RE: Pawling Commons
Amended Site Plan
63, 67, 71 East Main Street
Tax Map No. 7056-05-101917

Memorandum from Sara Drury, EIT, LaBella Associates, dated January 3, 2024:

DRAWING: **VEHICLE MANEUVERING PLAN**

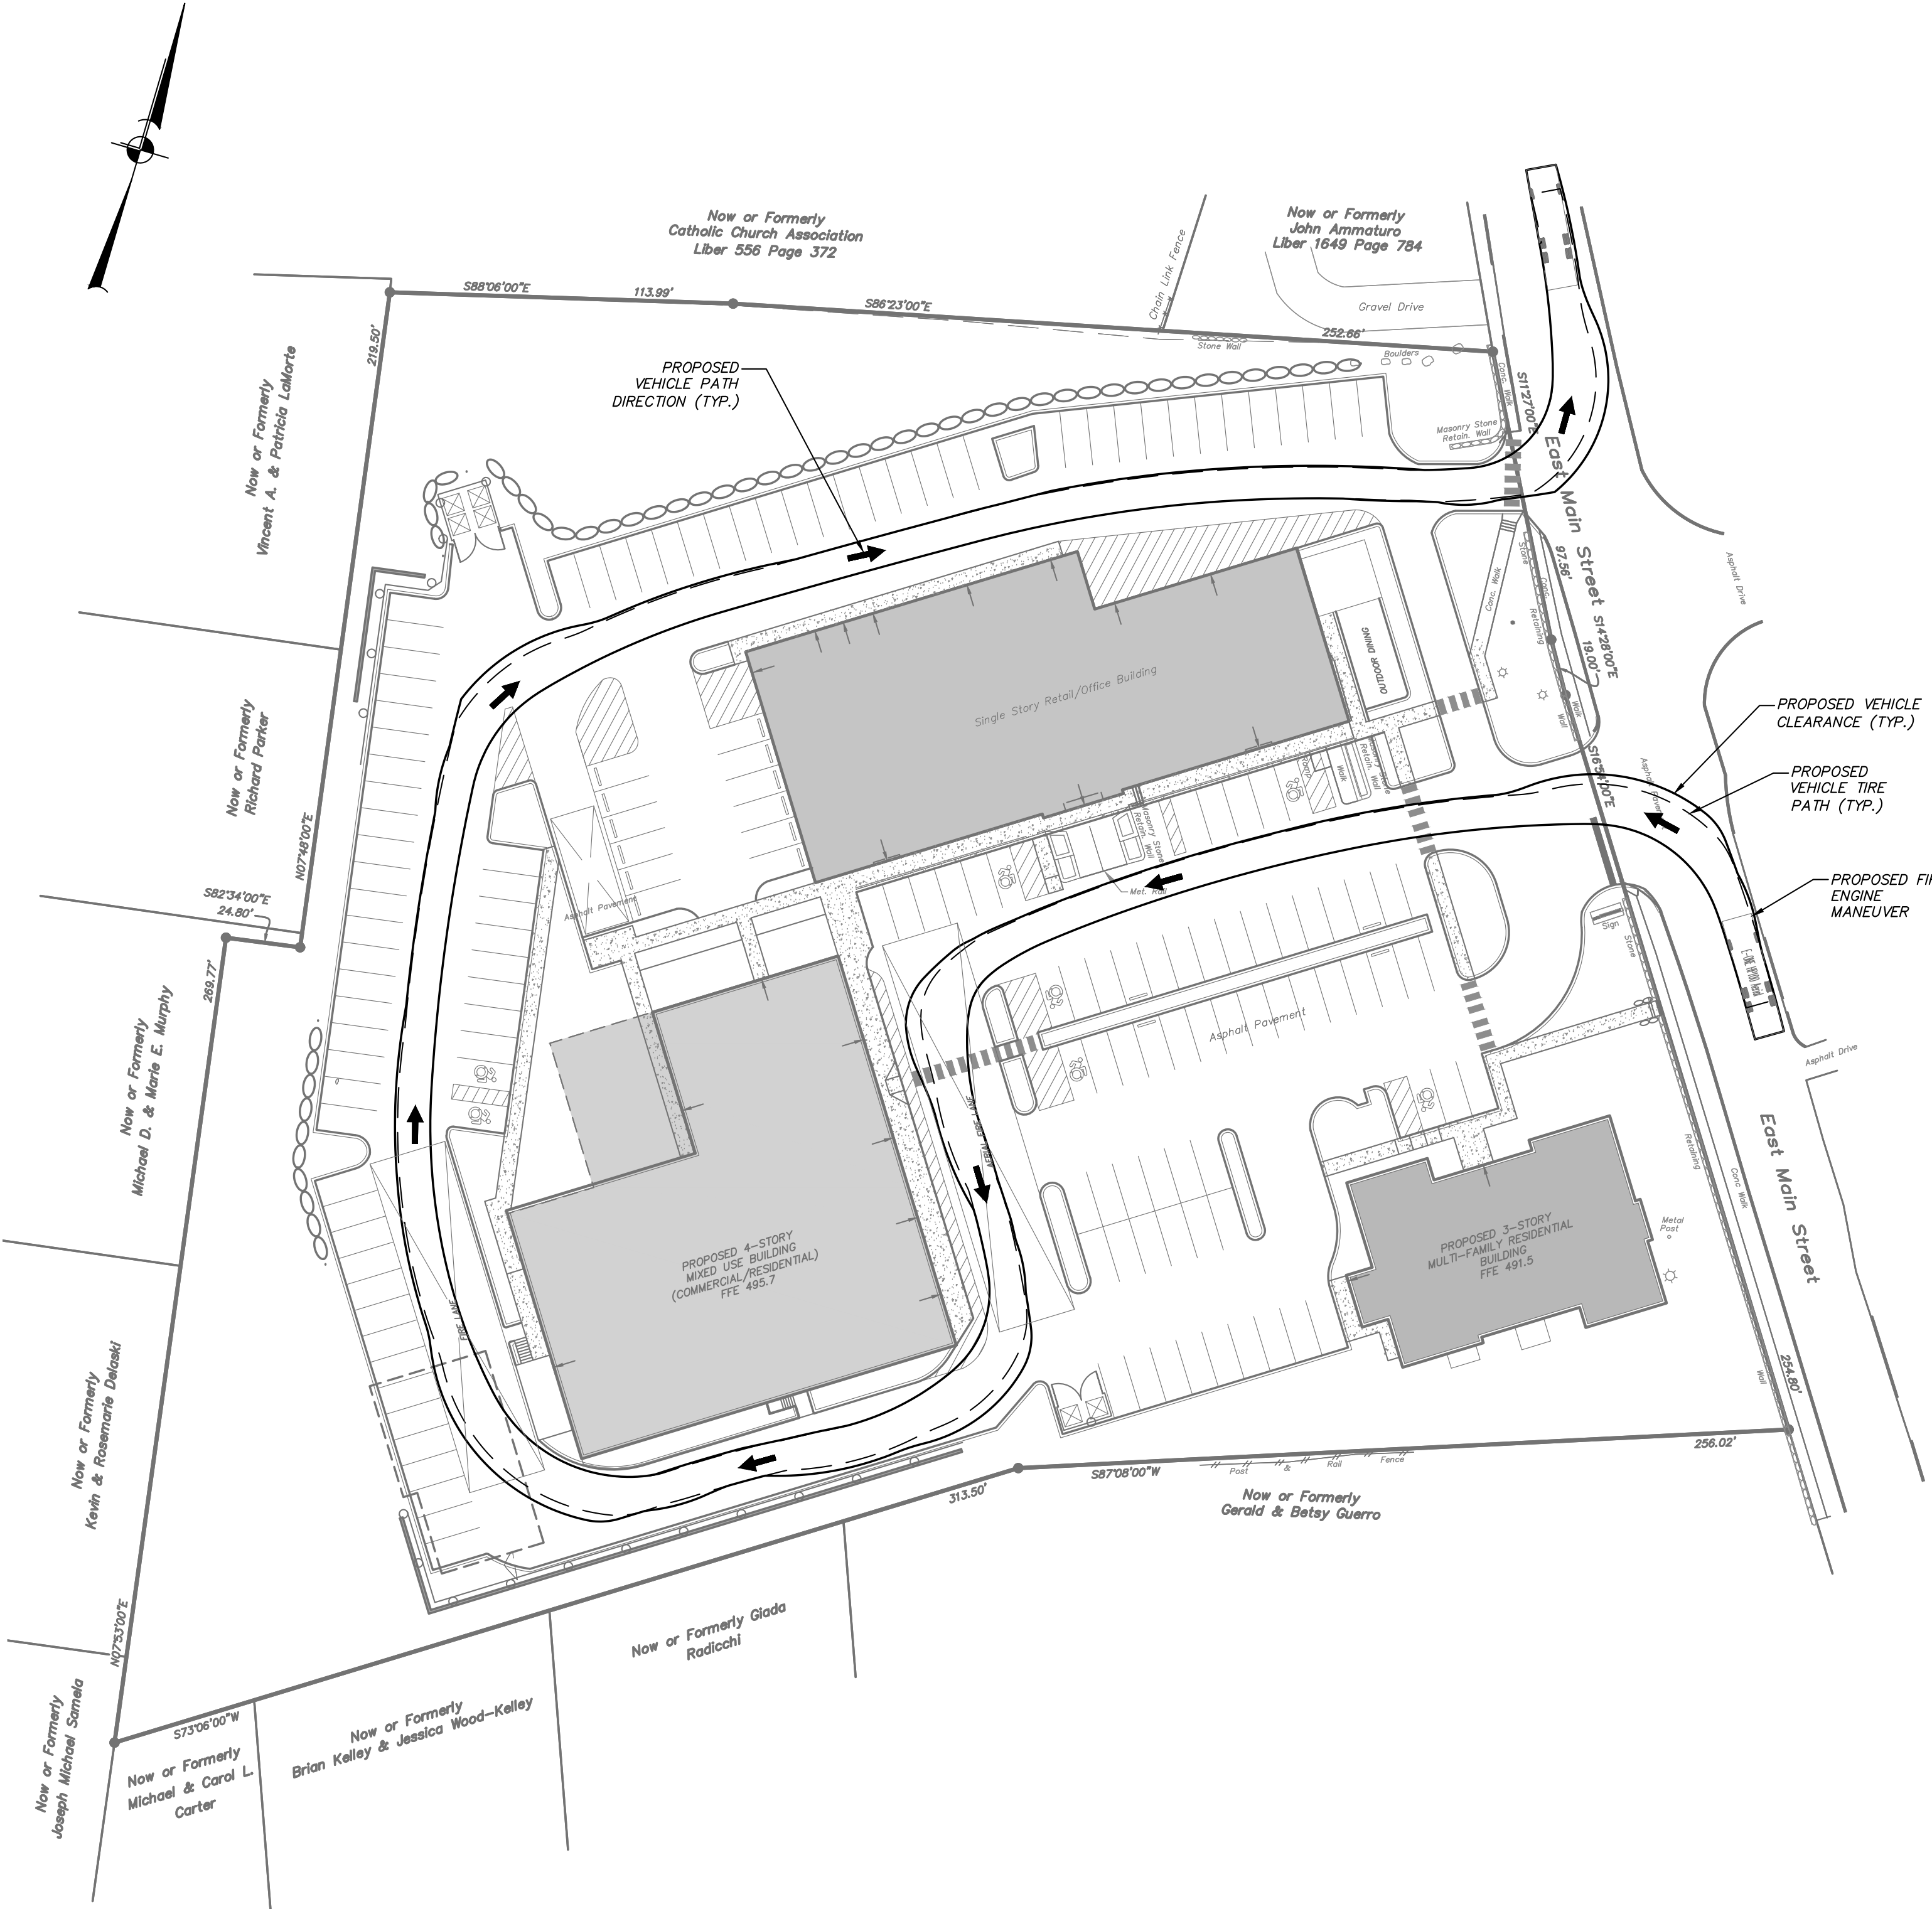
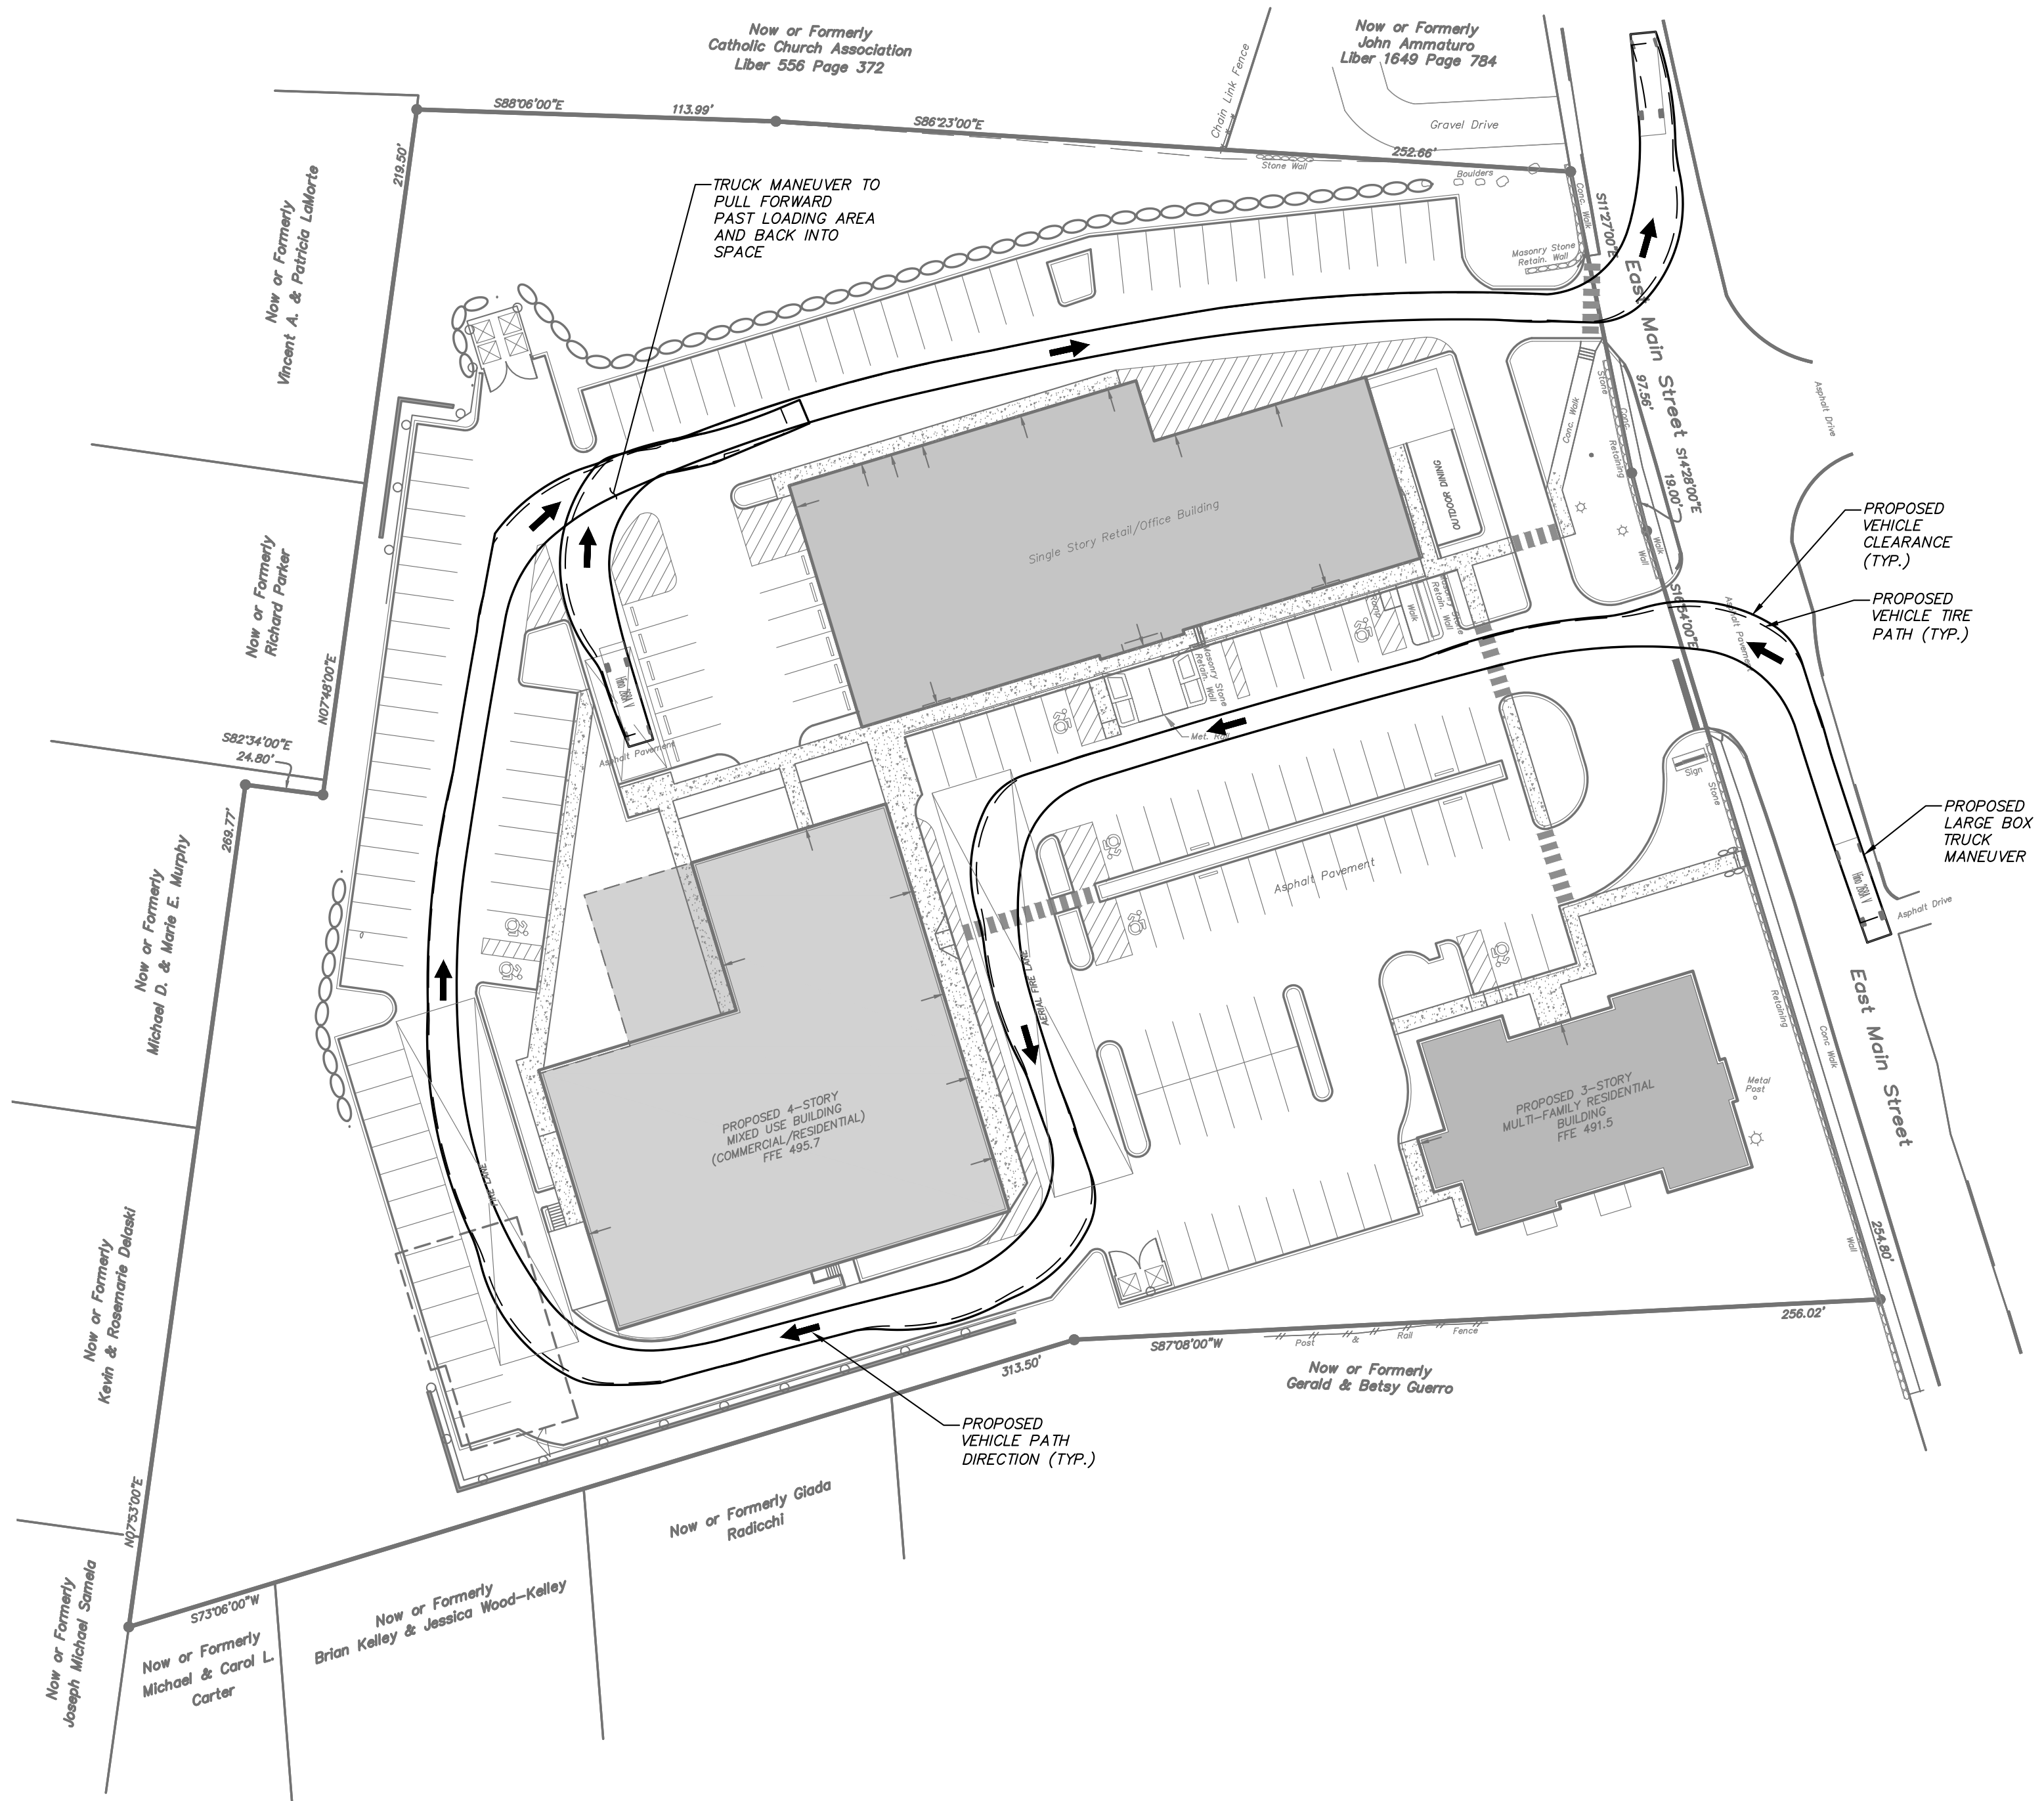
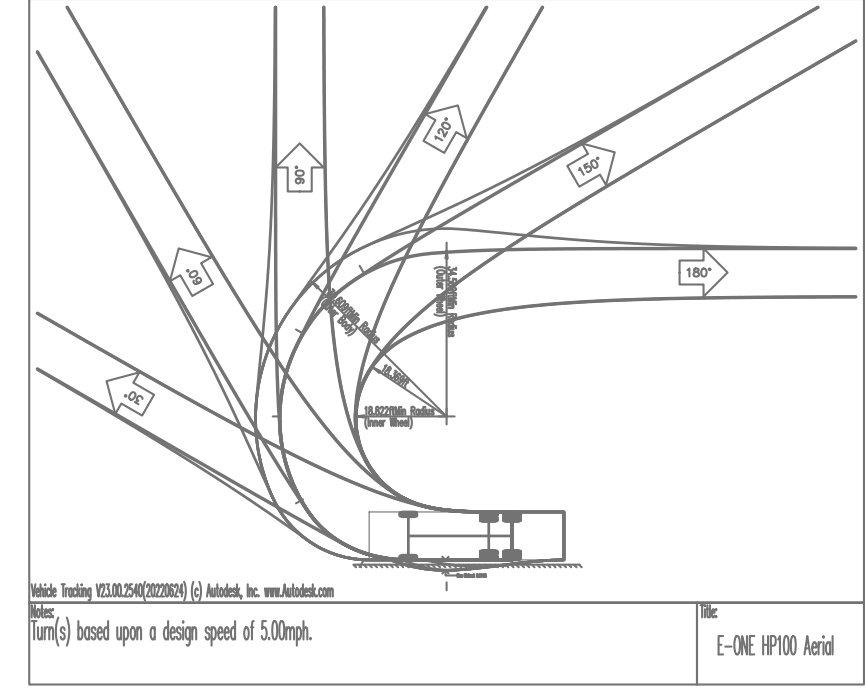
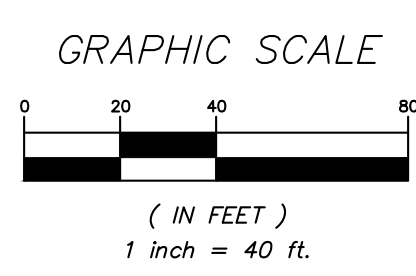
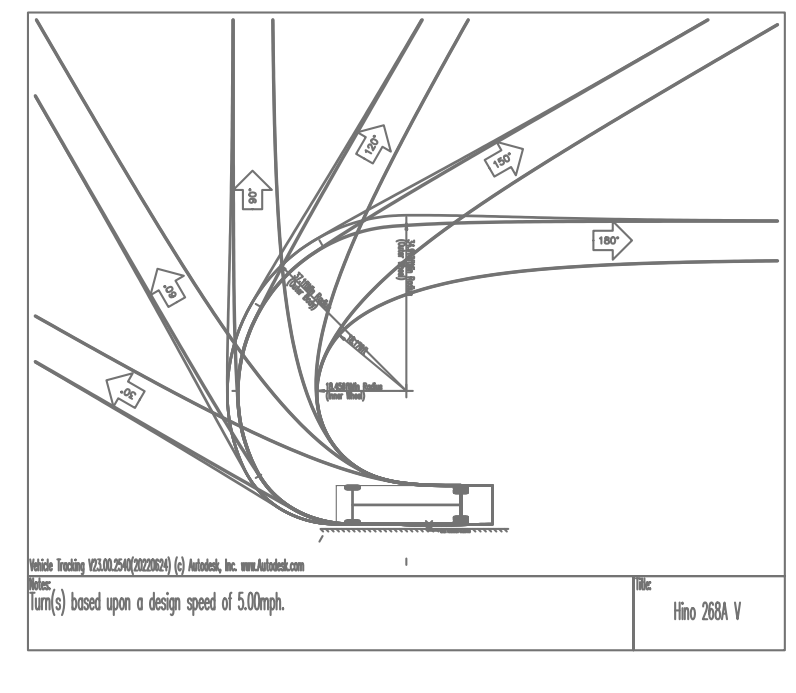
1. The large box truck maneuvering into the loading area is intended to pull forward past the loading area and back into the space. Therefore the reverse movement into the loading area overlaps with the forward movement pulling out of the loading area. A callout has been added to the Vehicle Maneuvering Plan to clarify.
2. The project plans have been sent to the Fire Department and Christopher Maeder of Labella for their review and acceptance. A determination from the Fire Department will be provided upon receipt.

FIRST DEFENSE OPTIMUM HYDRODYNAMIC SEPARATOR FDO-3
(HDS 7, HDS 8, & HDS 13)
(N.T.S.)

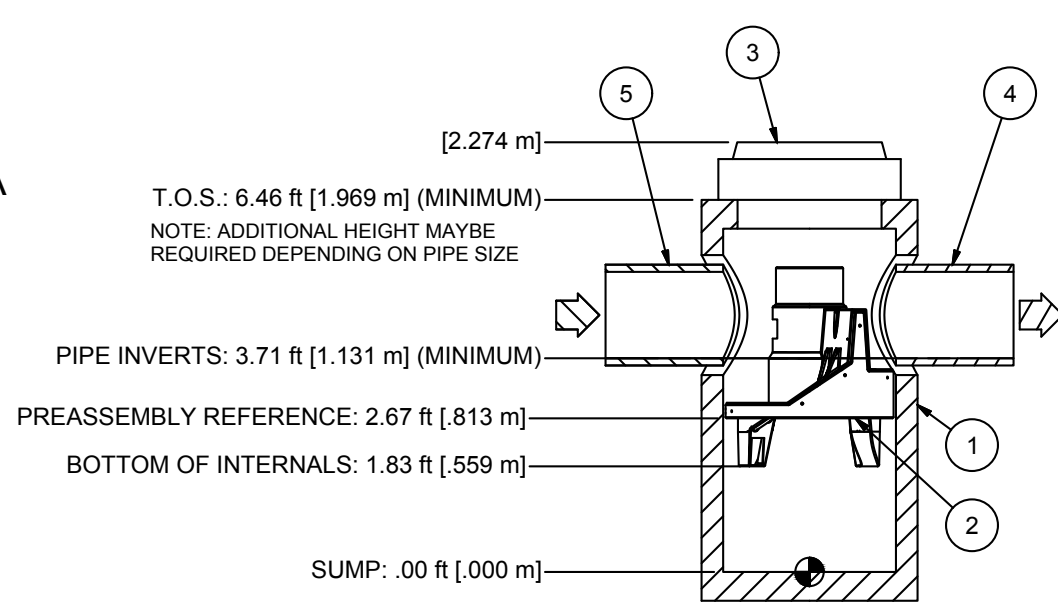
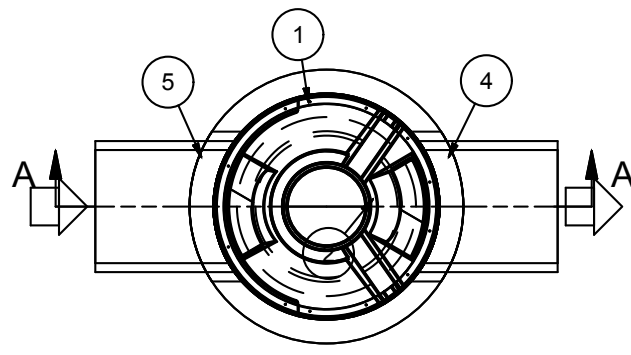
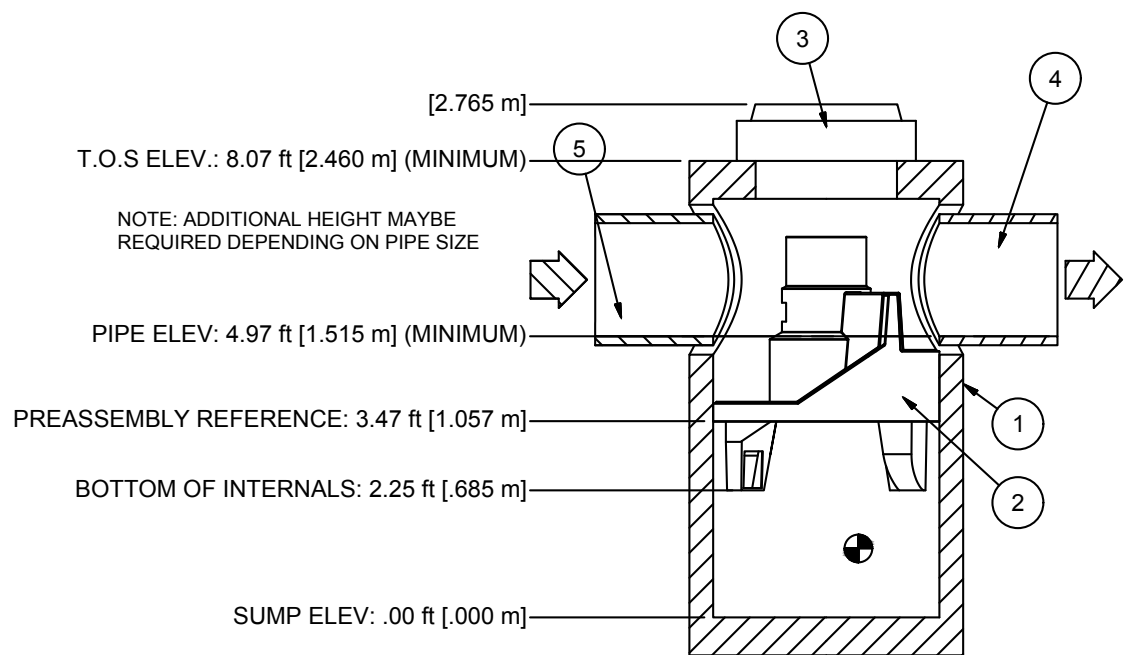
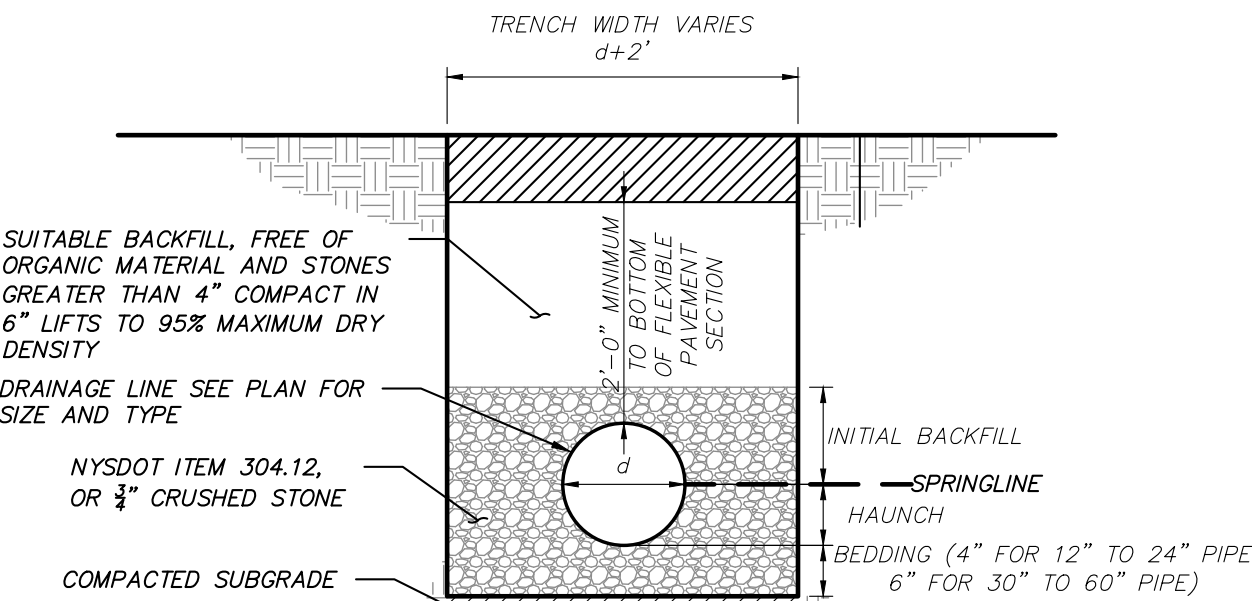
1. Comment addressed.
2. Drawing D-3 has been revised to provide separate standard details for the proposed 3-ft and 4-ft First Defense hydrodynamic separators. Furthermore, the Drainage Table on Drawing GU-1 has been revised to provide the minimum required dimension from the top of slab elevation to the invert elevation for the proposed hydrodynamic separators per the corresponding standard detail from Hydro International.
3. Comment addressed.
4. Comment addressed.
5. Comment addressed.
6. The project plans have been sent to the Fire Department and Christopher Maeder of Labella for their review and acceptance. A determination from the Fire Department will be provided upon receipt.
7. Comment addressed.
8. Comment addressed.
